**Glastonbury Riverfront Park
Phase Two Improvements
Project No. GL-2013-22
Glastonbury, CT.**

**ADDENDUM NO. 005
May 23, 2013**

EXHIBIT "A"
SKA-C1 MDC WATER PIPE INSULATION DETAIL

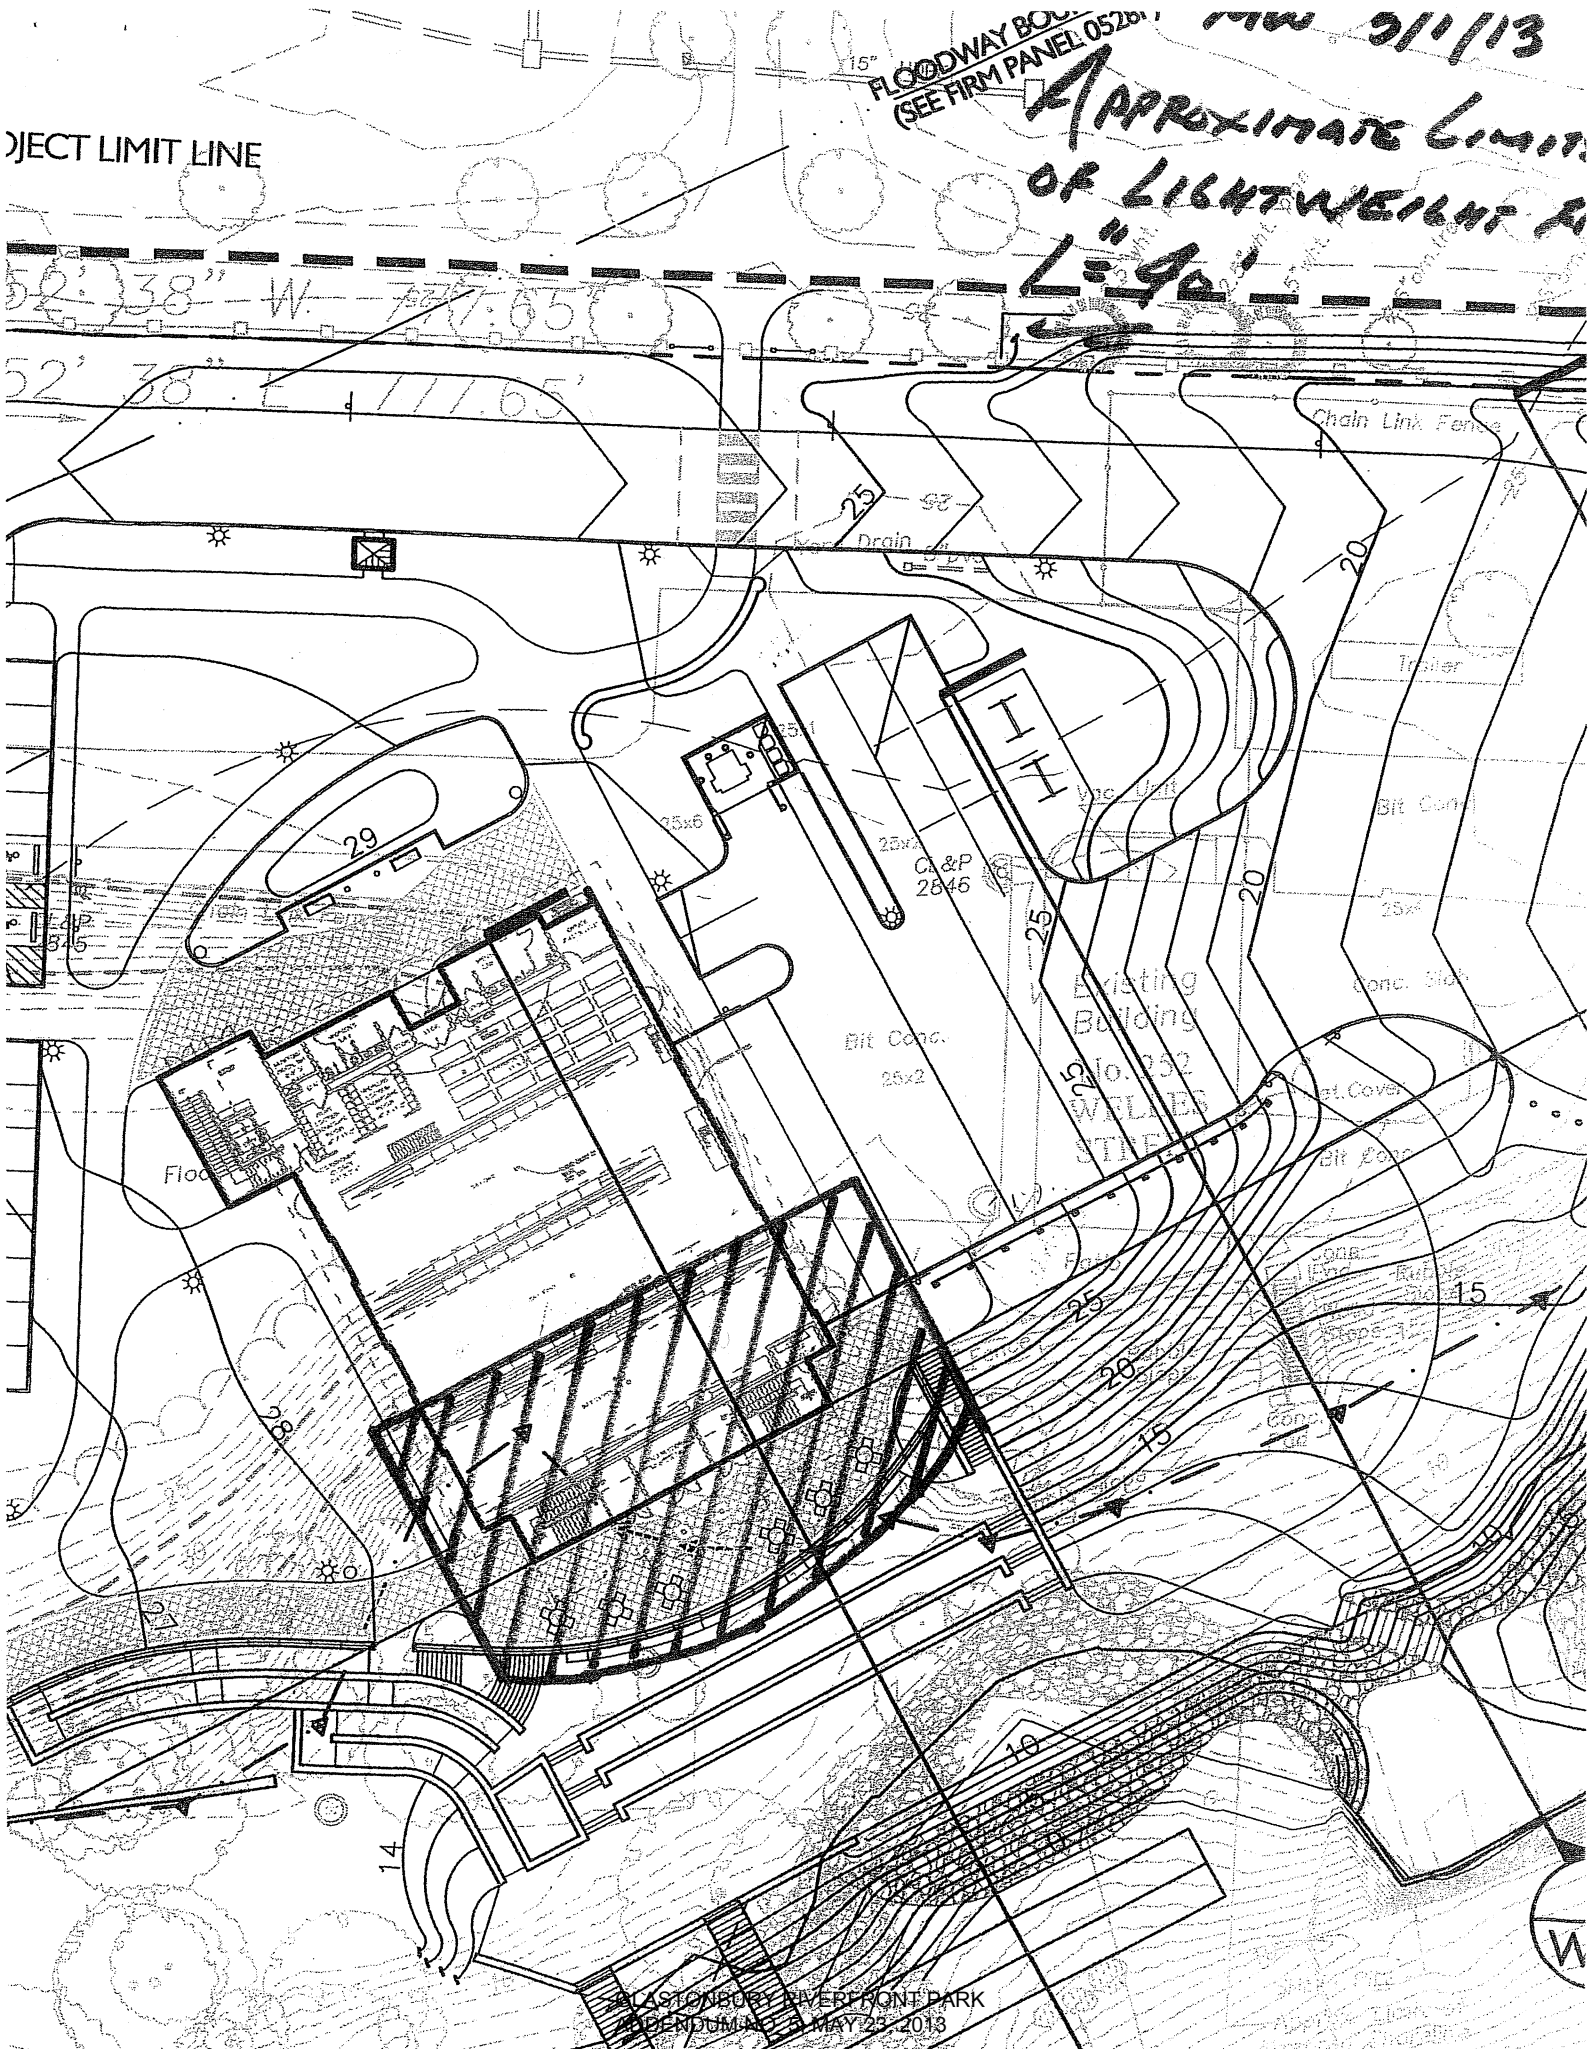
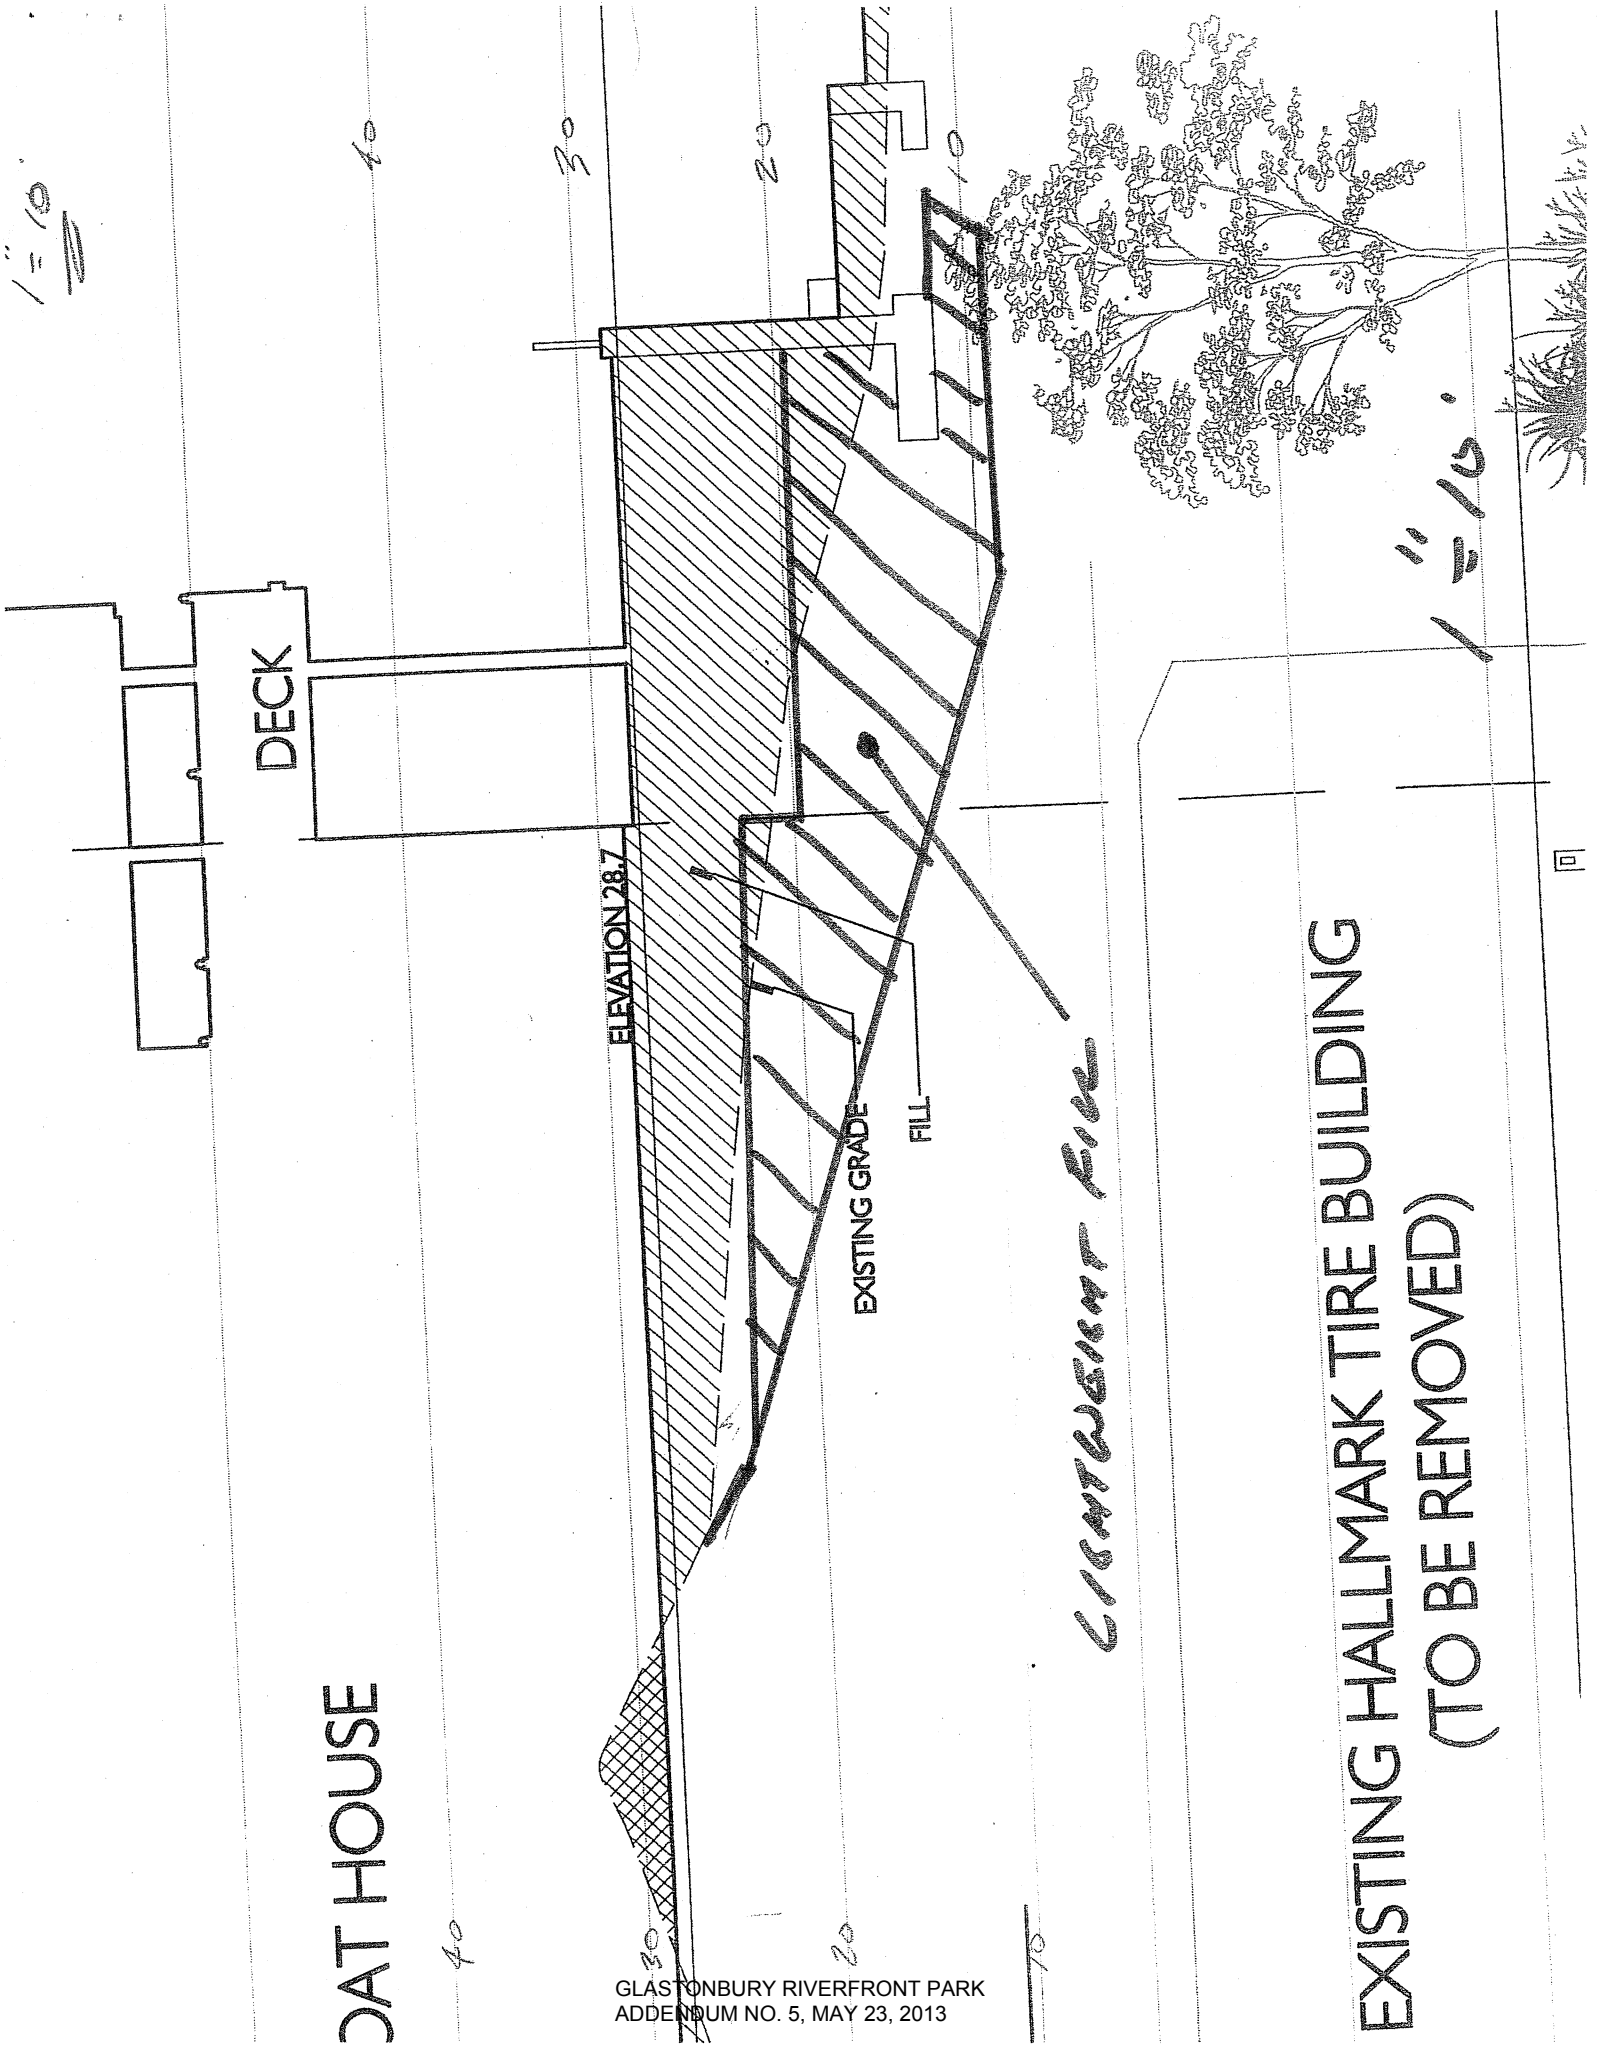
Work Plan required to be submitted to the Construction Manager prior to the commencement of work within 25’ of the MDC 20” Water Main is to include the installation of 2” insulation above the water line as shown in the attached SKA-C1. All cost associated with the insulation requirements of the MDC 20” water main shall be included in the base bid and in accordance with the SKA-C1 attached to and made a part of this Addendum. See Exhibit “A”

Reference: Drawing number : A-010 Detail: _____ Spec. Section: _____

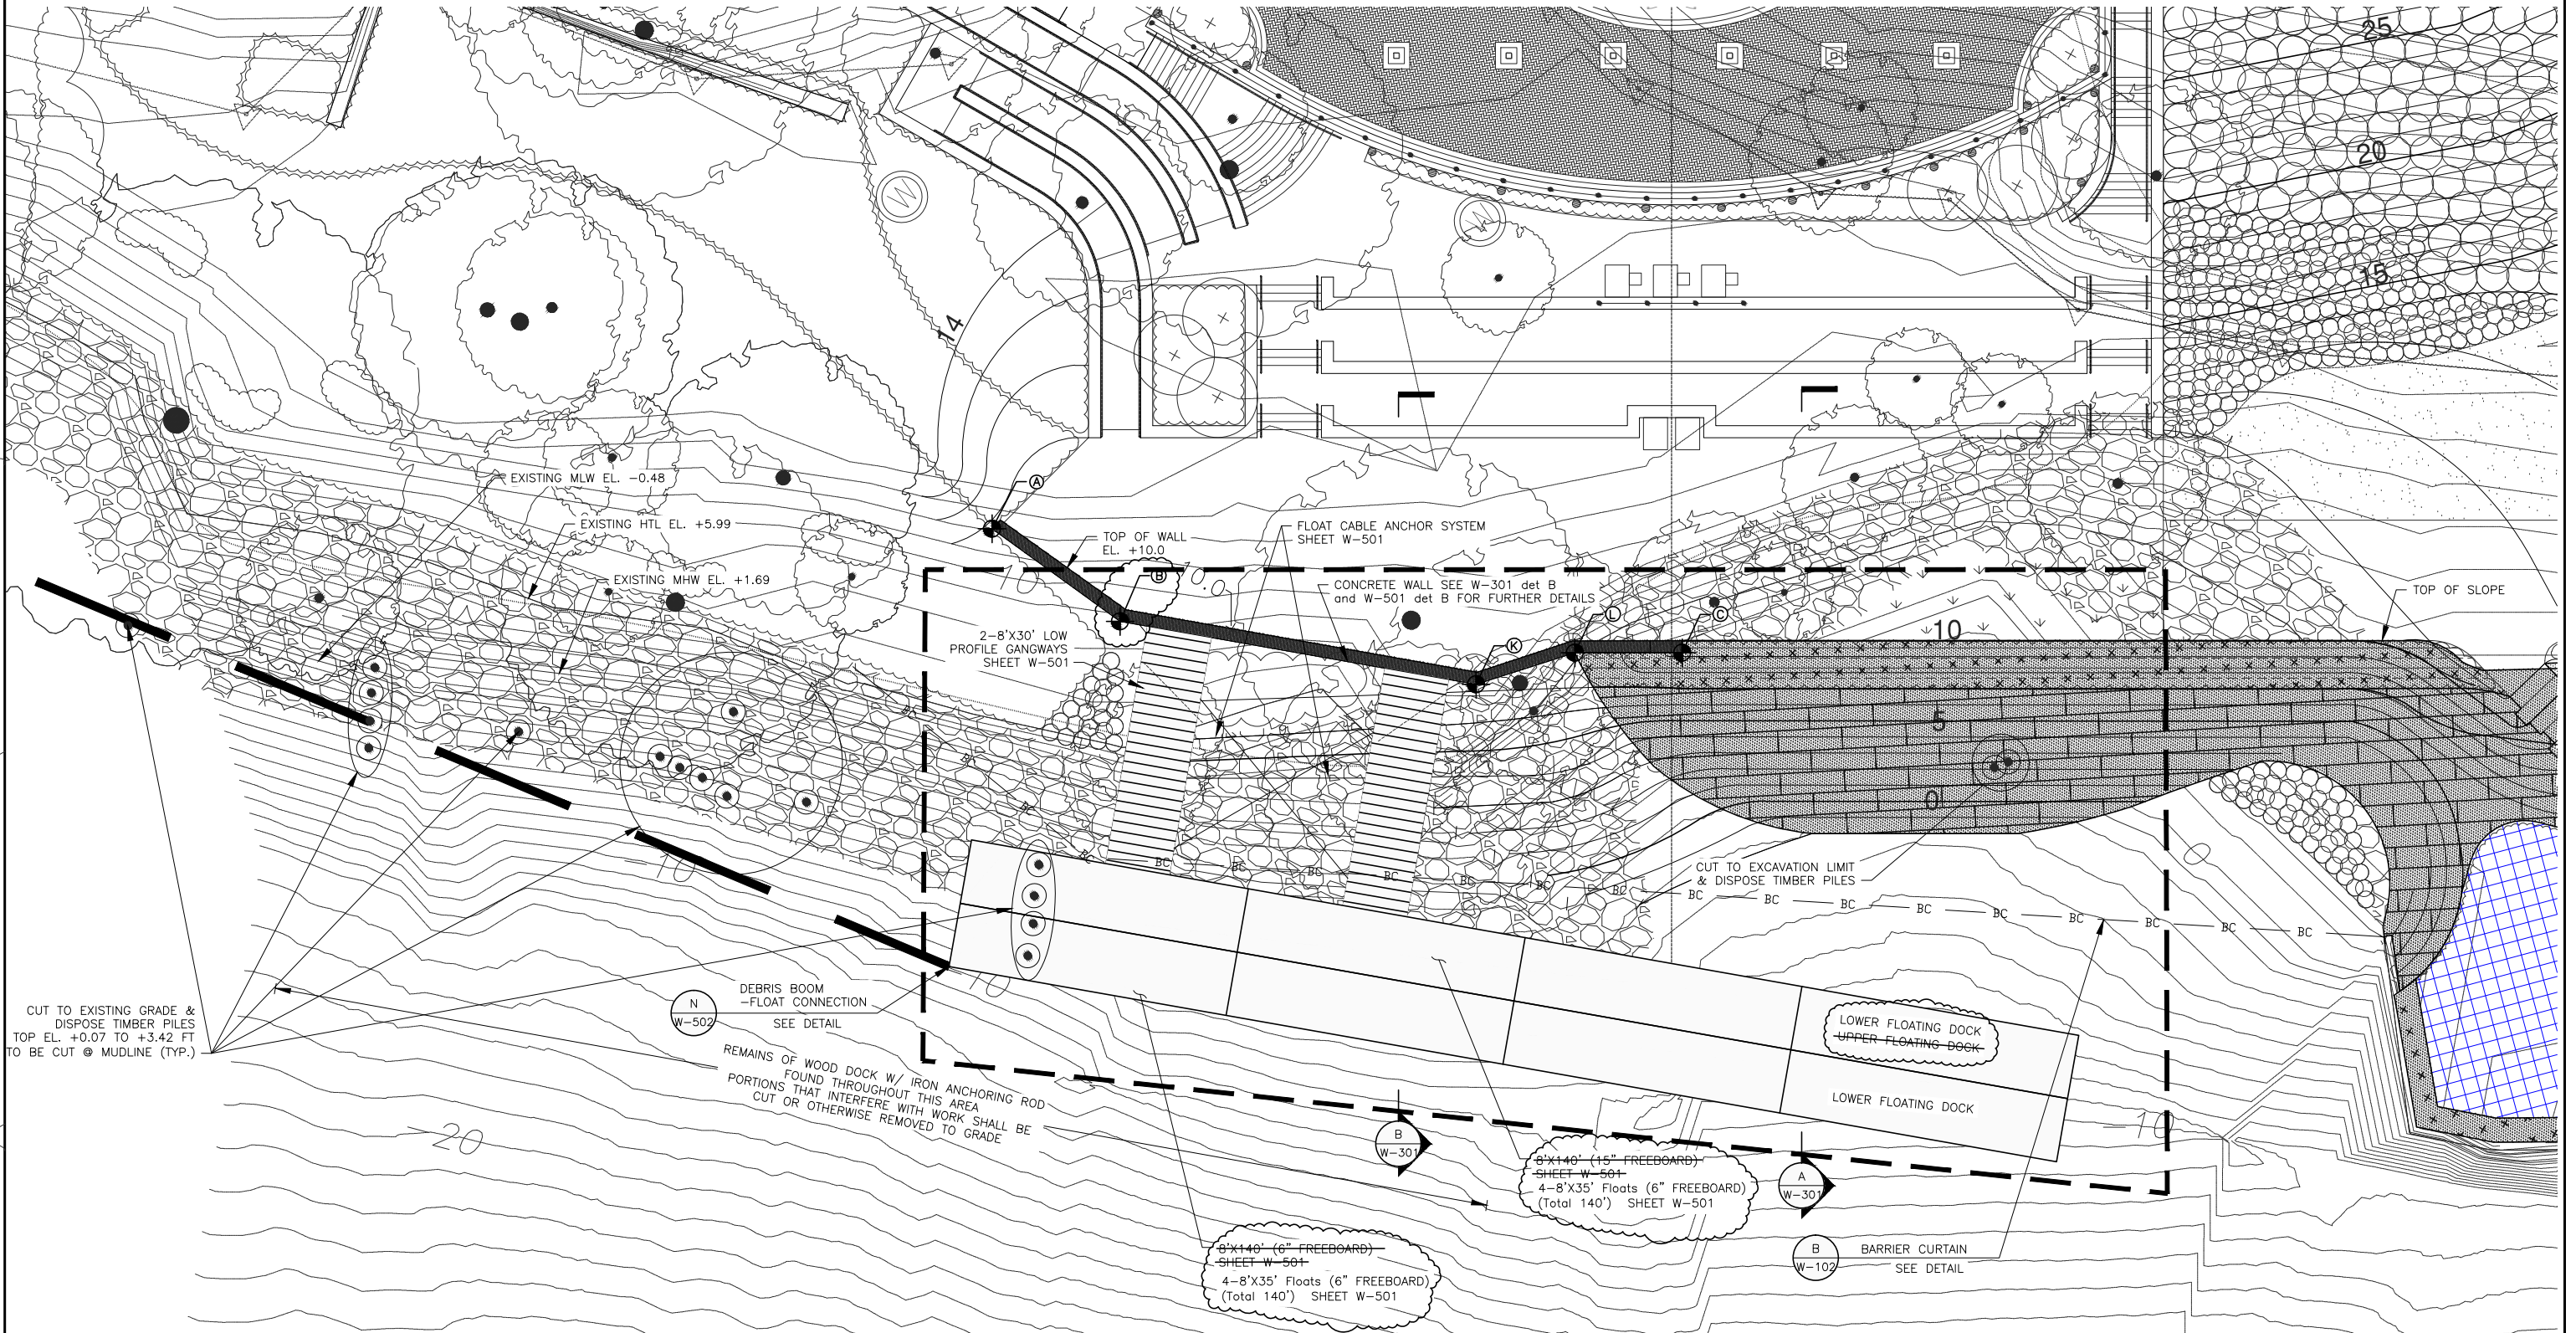
Drawing A-010 partition type 8 which is the most common of the exterior walls has no spray foam insulation, while typ3 7 walls do have spray foam insulation. Should wall type 8 and 8B have spray foam insulation? Please advise

Wall type 8 is only used for the first floor and at areas where there are unheated interior spaces. No insulation is required.
